Pre-Application Report

Case Number / AMANDA No.	PRE-AP20-51 / 20-108558-PA
Conference Date	June 15, 2020
Applicant	JCT Construction Group, LLC 201 Ferry Street SE, Suite 400 Salem, OR 97301
Contact	Brandie Dalton Multi-Tech Engineering, Inc. 1155 13 th Street SE Salem, OR 97302
Case Manager	Aaron Panko

Project Description & Property Information	
Project Description	A pre-application conference to discuss development of a 24-unit multi-family apartment complex, for property approximately 1.77 acres in size.
Property Address	1400 Block of Mildred Lane SE - 97306
Assessor's Map and Tax Lot Number	083W14CB / 02401 and 02501
Existing Use	Vacant
Neighborhood Association	South Gateway Neighborhood Association
Adjacent Neighborhood Association	NA
Comprehensive Plan Map Designation	Industrial Commercial and Single Family Residential
Zoning	IC (Industrial Commercial) and RA (Residential Agriculture)
Overlay Zone	NA
Urban Service Area	The subject property is located outside the Urban Service Area.
Urban Renewal Area	NA
Past Land Use Actions	PAR19-11, SPR-DAP19-28, SPR-DAP18-07, CPC85-20 and CPC-84-07

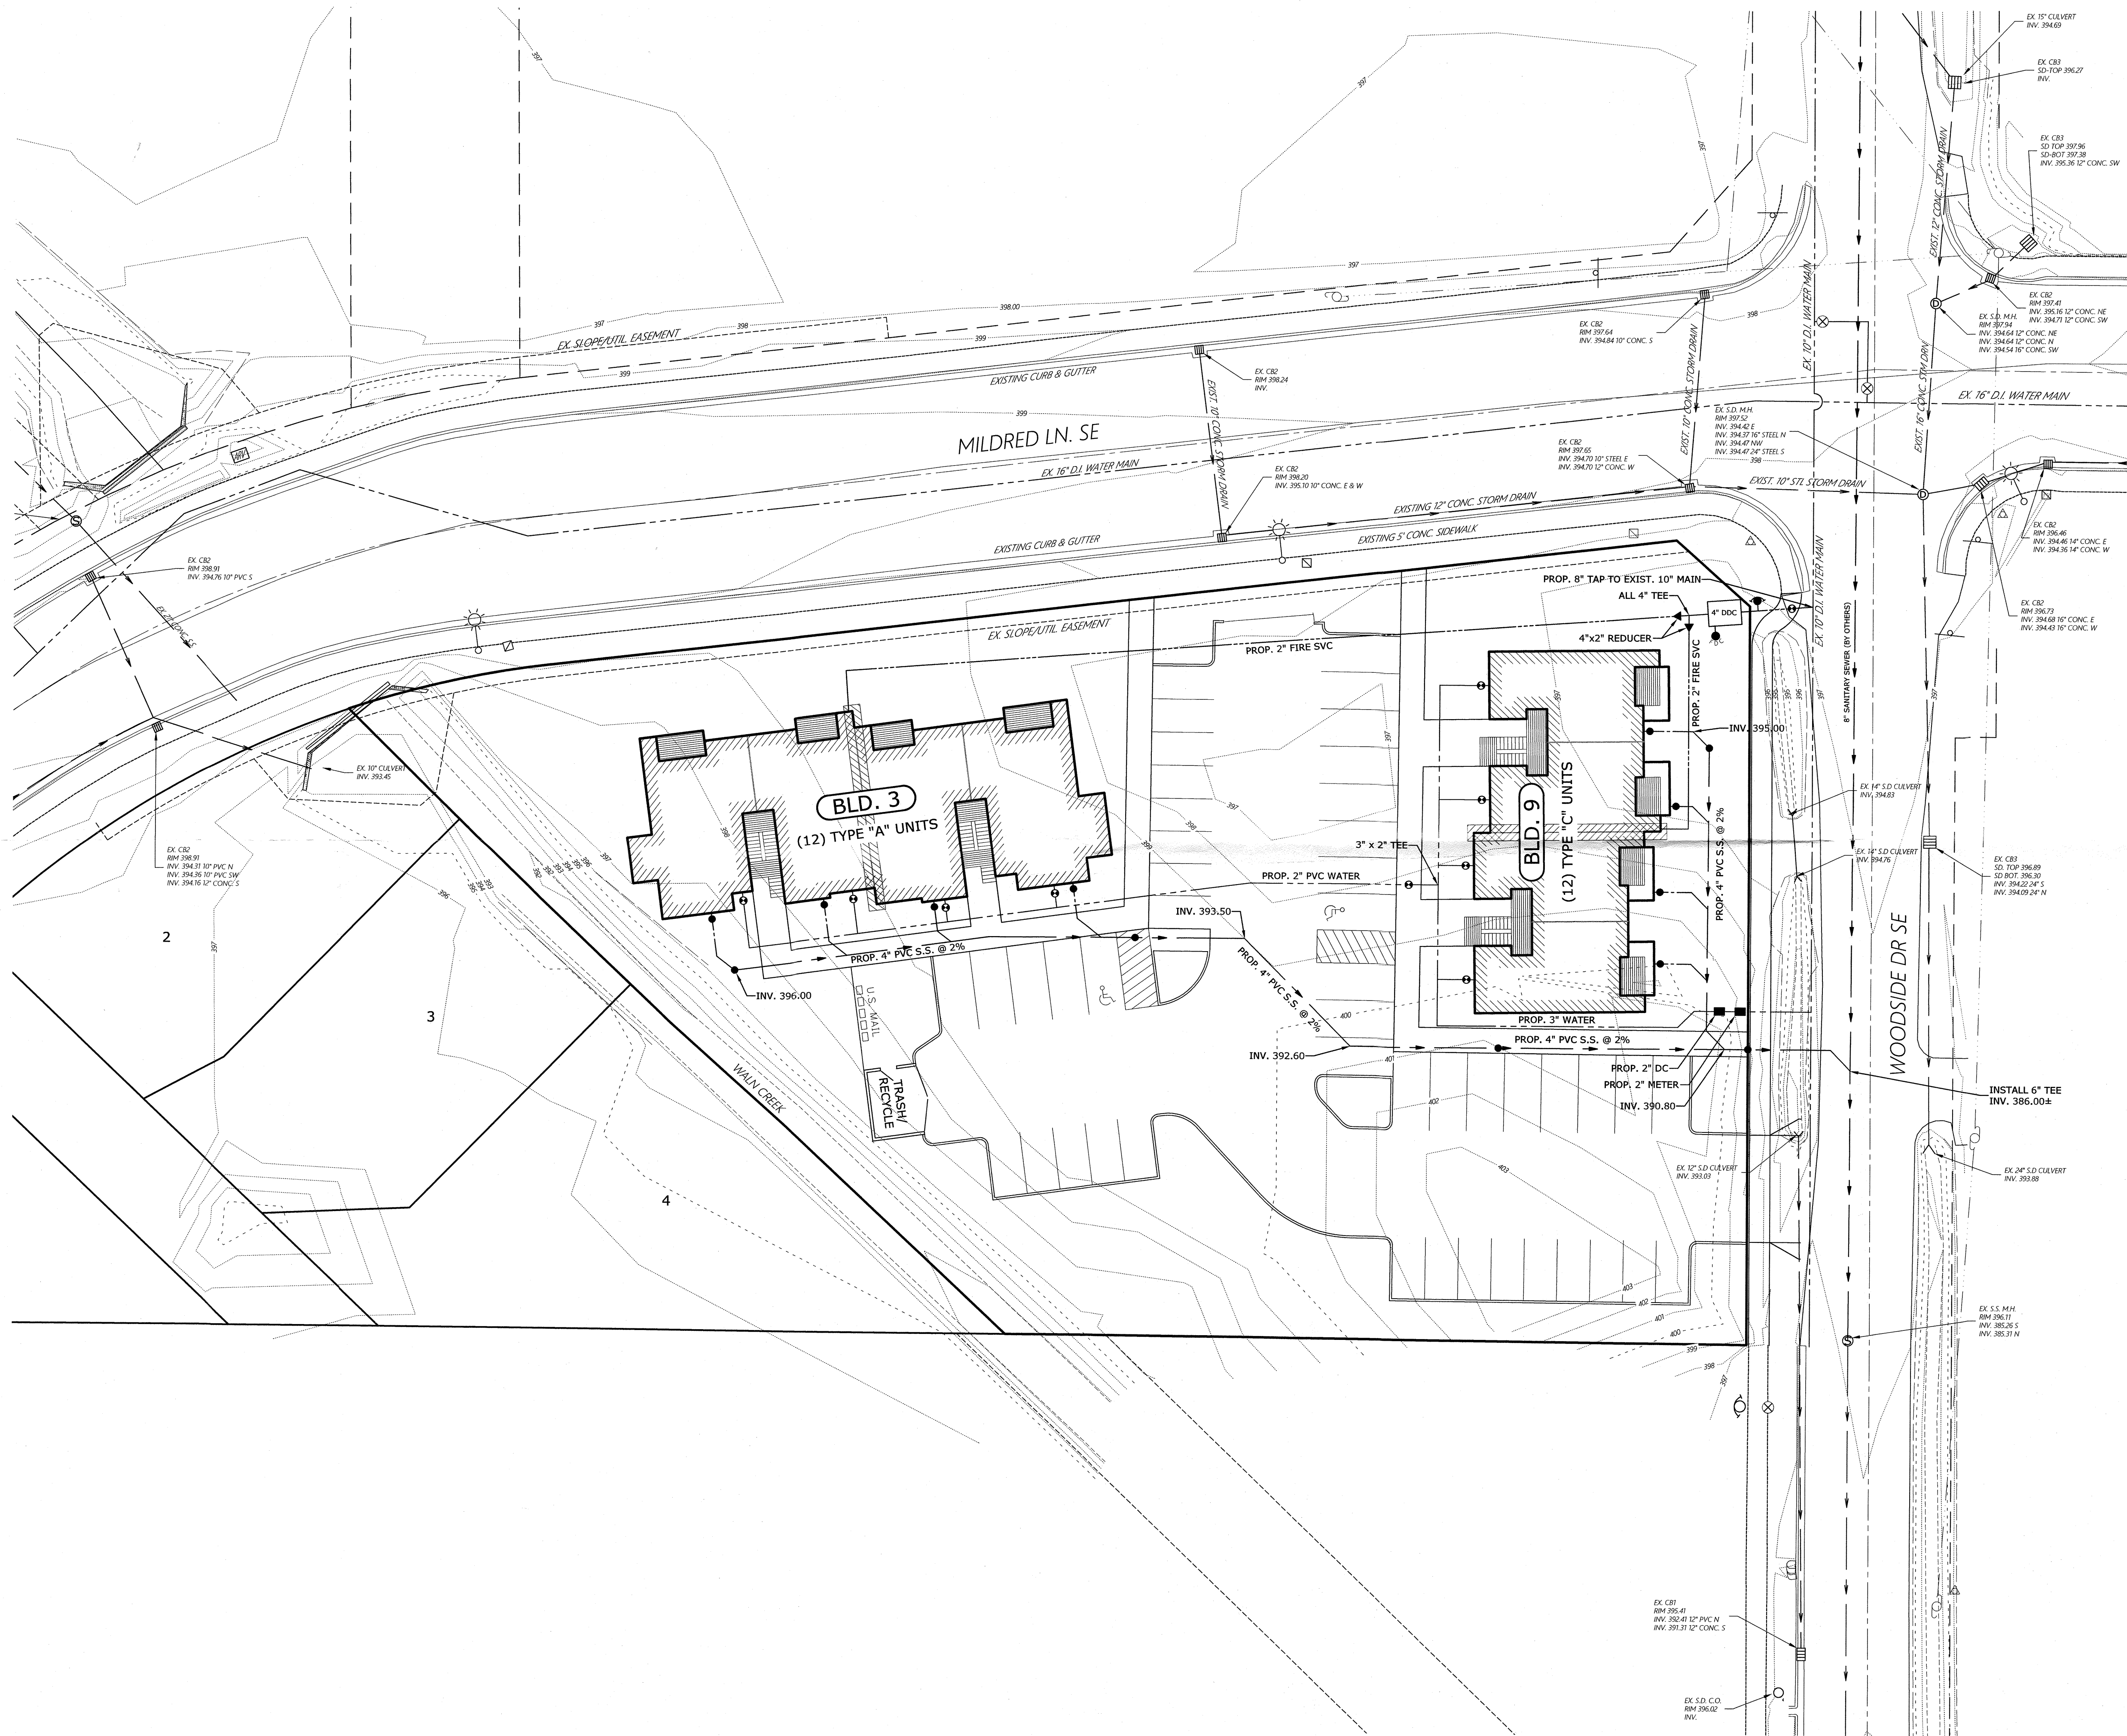
Staff Response: Buildings are not placed on the setback line abutting Mildred Lane SE or Woodside Drive SE.

Staff Response: Direct pedestrian access is not provided between the building entrances and adjacent sidewalks.

Staff Response: Fences are proposed between the dwelling unit entryways and abutting streets.

Staff Response: Off-street parking area adjacent to Mildred is located in front of building, not to the side. This issue may be corrected if the buildings are placed at the setback line.

Staff Response: Pedestrian crossings required through parking area.

OPEN SPACE
PLAN

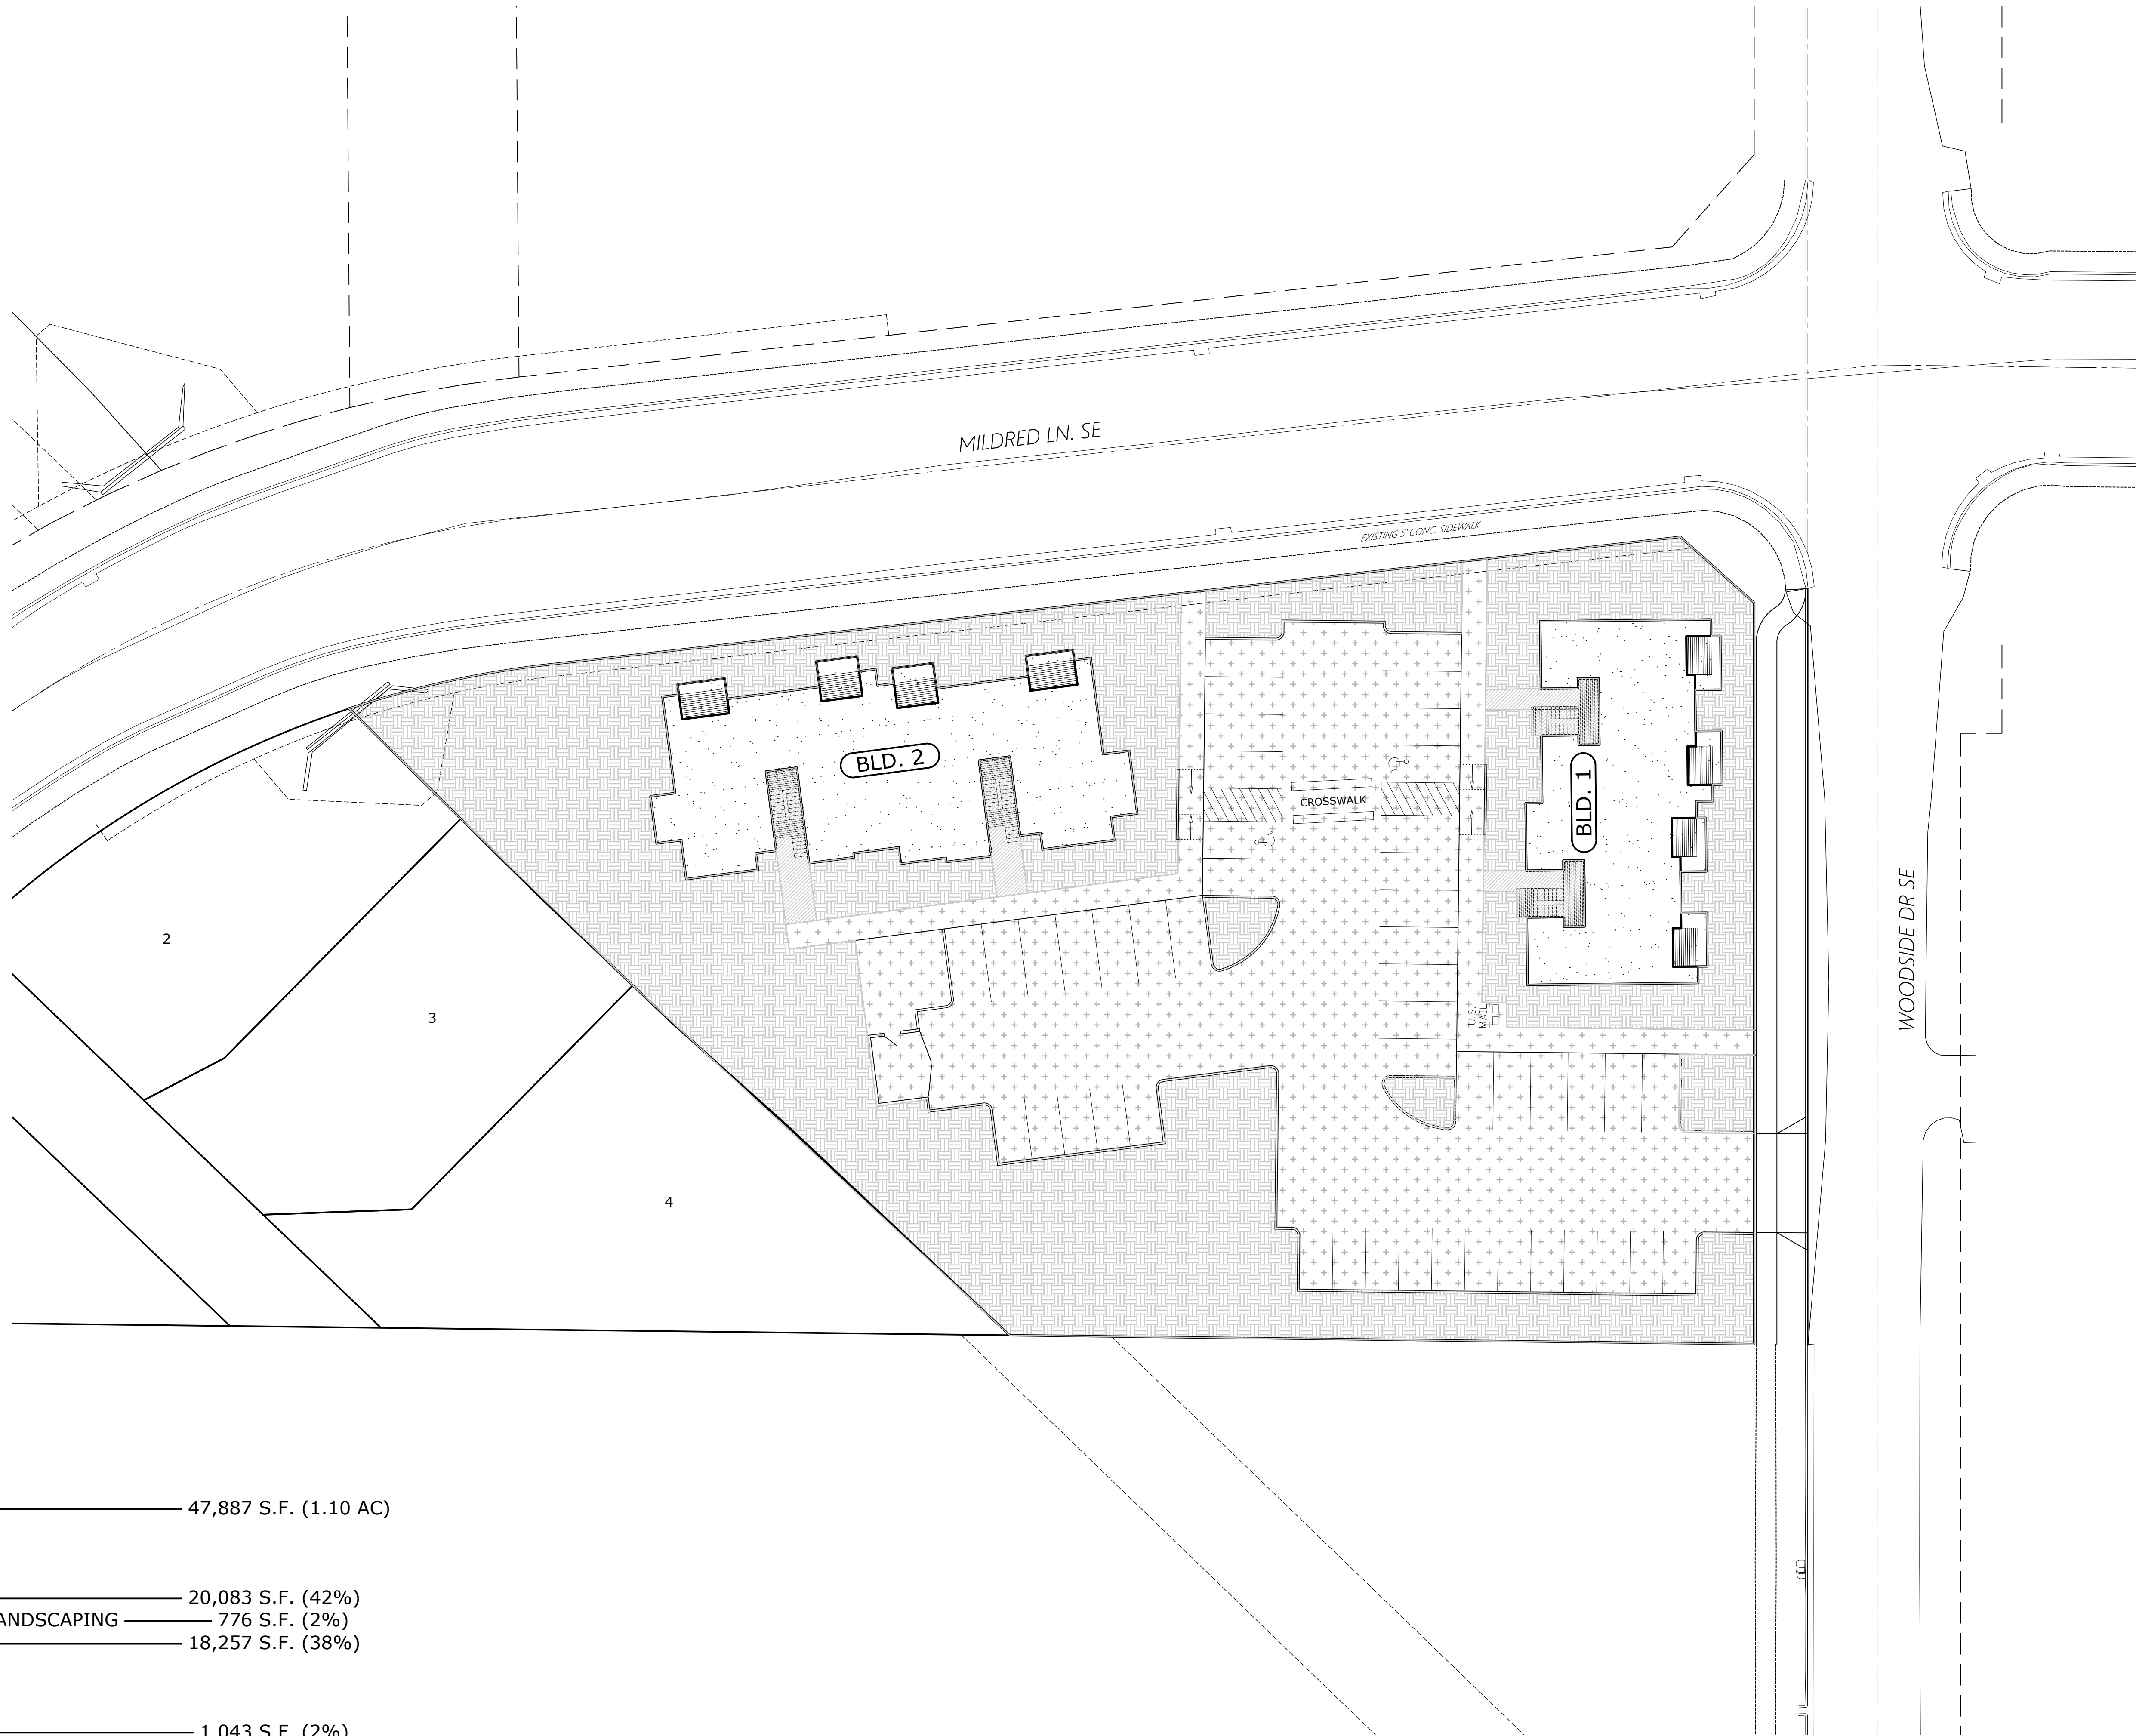
- 4) SRC 702.020 – Design review standards for multiple family development with thirteen or more units.
 - a. To ensure usable open space that is of sufficient size, at least one common open space area shall be provided that meets the size and dimension standards set forth in Table 702-3. To ensure the provided open space is usable, a maximum of 15 percent of the common open space shall be located on land with slopes greater than 25 percent.

Staff Response: The open space plan does not indicate where the required open space area will be provided, or demonstrate that the area is in compliance with SRC 702.020(a)(1)(A and B).
